REMEDIAL ACTION
CONSTRUCTION COMPLETION
REPORT

VOLUME II
AS-BUILT DRAWINGS
& DESIGN CHANGE FORMS

Pine Street Canal Superfund Site
Burlington, Vermont

DESIGN CHANGE FORMS

CANAL CROSS SECTIONS T₅ & T₉
 PINE STREET CANAL SITE
 BURLINGTON, VERMONT

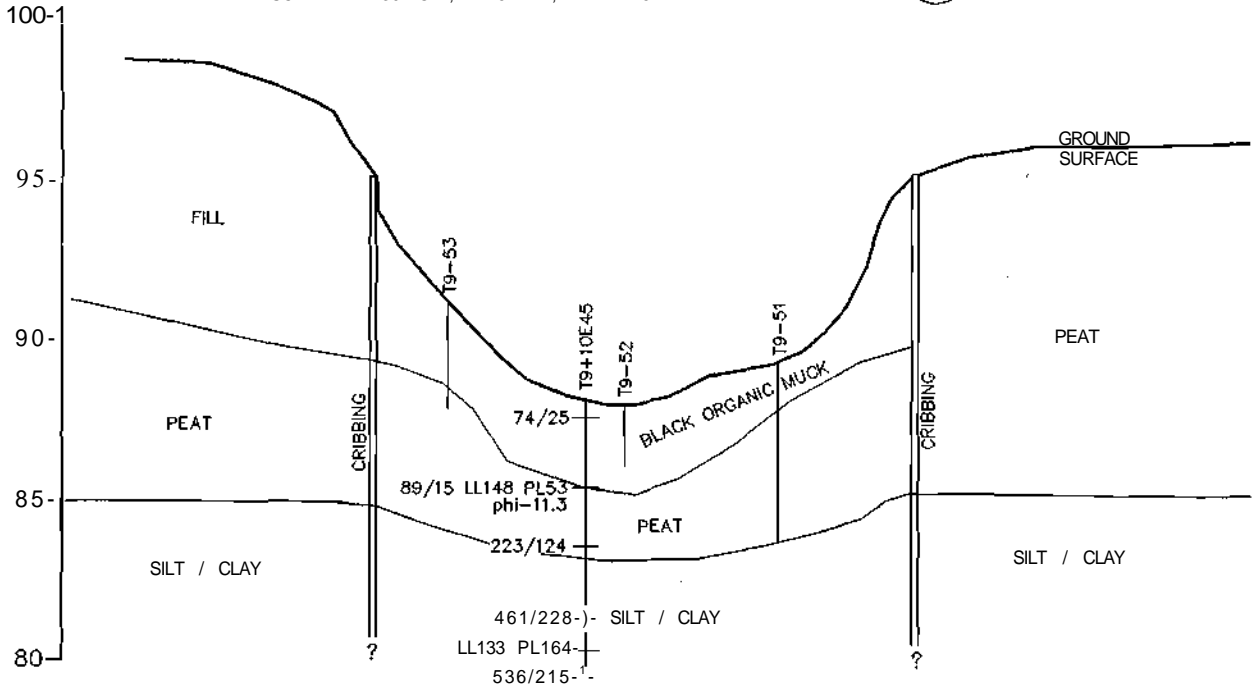
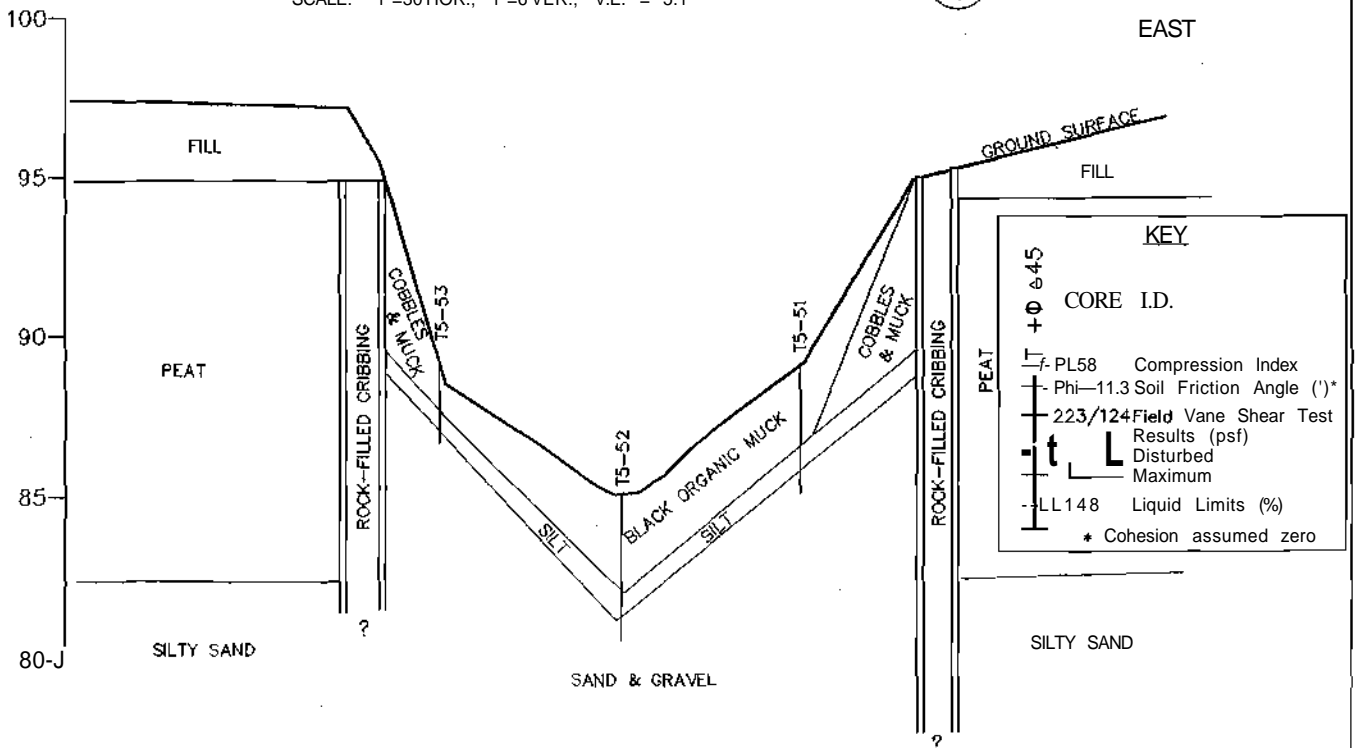
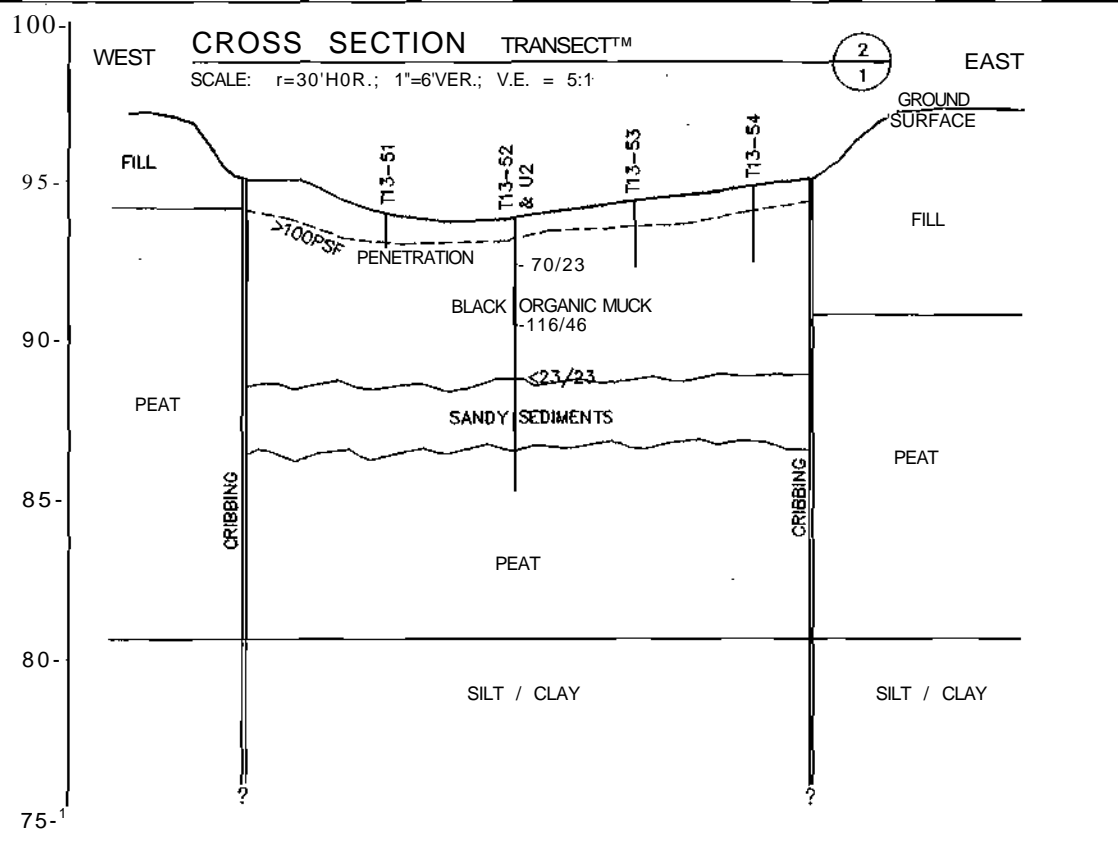
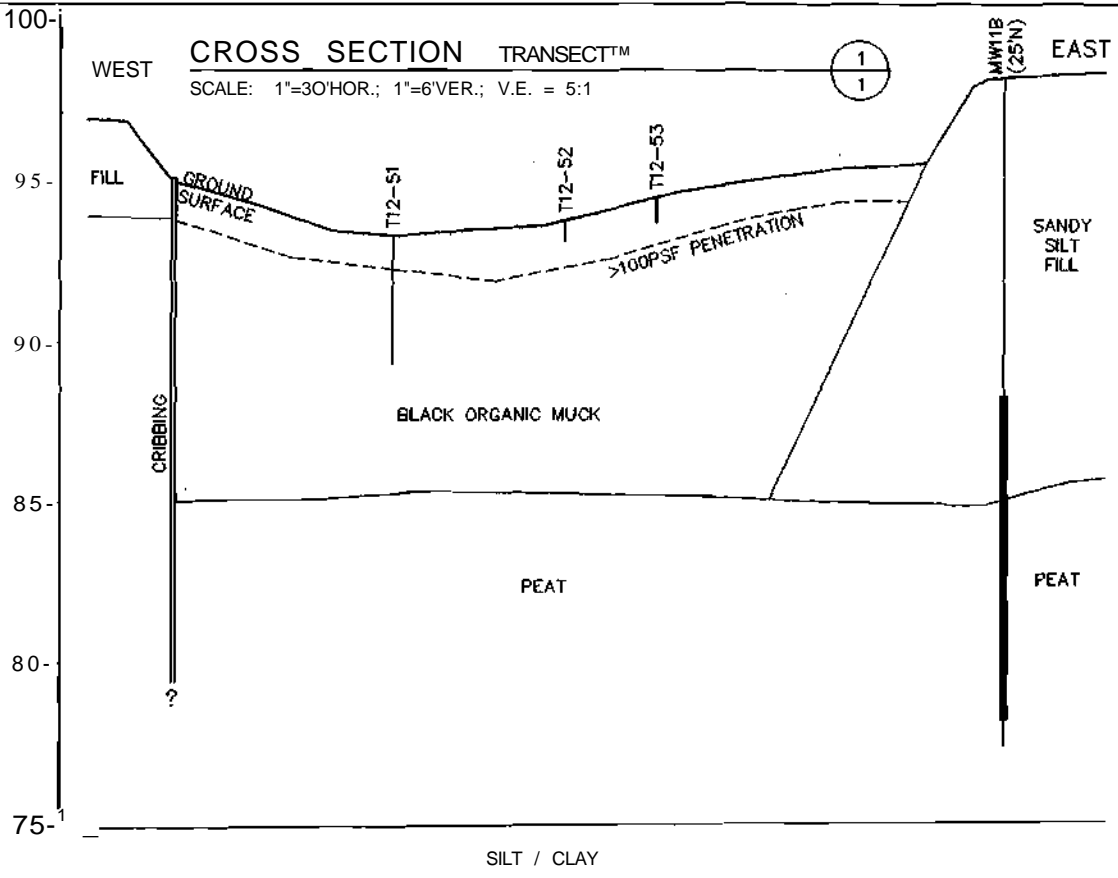
Cross sections for the Canal at Transects T5, T6+50, T9, T10+35, T12 and T13 are provided in Attachment 1 (Note: cross sections at Transects T6+50 and T10+35 were previously provided as Figure CDR 5-12 in the *Conceptual Design Report*, dated March 1, 2001).

**FIGURE 2 : HISTORIC RESOURCES
 IDENTIFIED SOUTH OF TURNING BASIN
 PINE STREET CANAL SITE, BURLINGTON, VT**

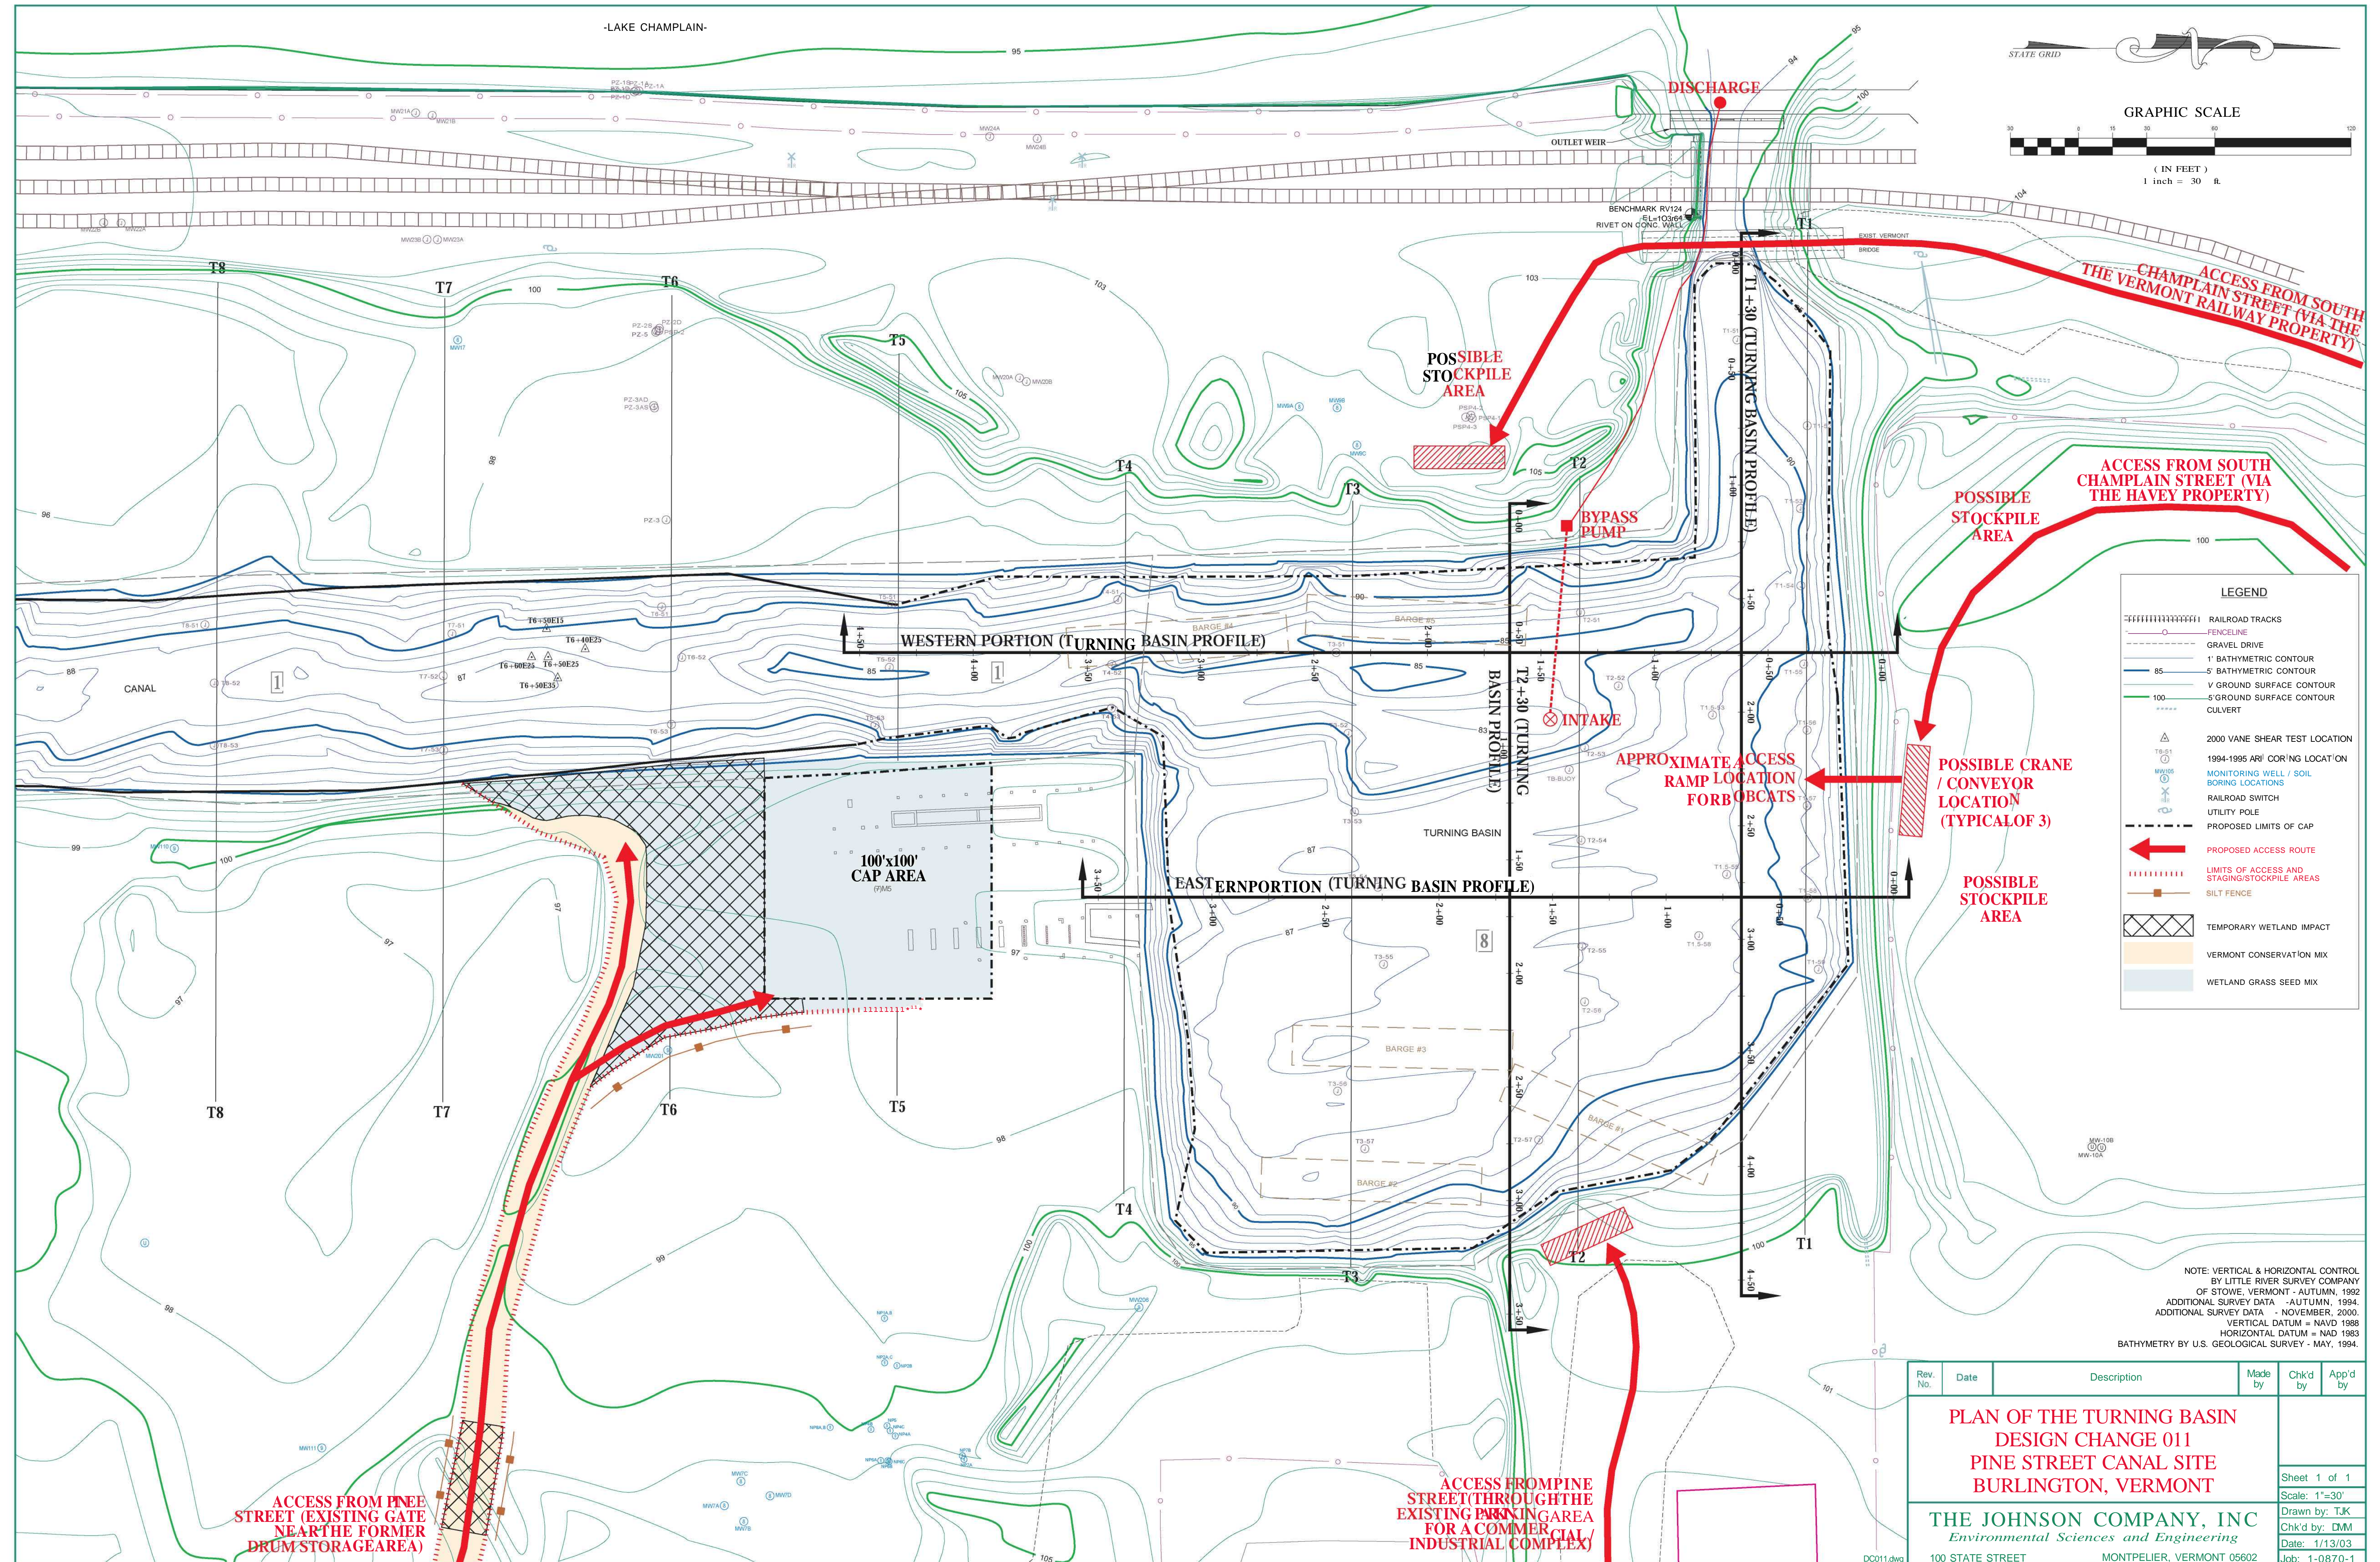
Historic relics associated with the marine railway structures in the south end of the Turning Basin are present within the 100 x 100 foot cap area. These relics have been located in the field using global positioning system (GPS) equipment and are shown in Figure 2 in Attachment 2. The relics will be flagged in the field prior to clearing and cap construction to ensure that they are not damaged by the construction activities. In addition, a meeting between *de maximis*, The Johnson Company, and Fleet Environmental will be held prior to any work in the area to go over the location of the relics, and the measures to be taken to avoid damaging these historic features.
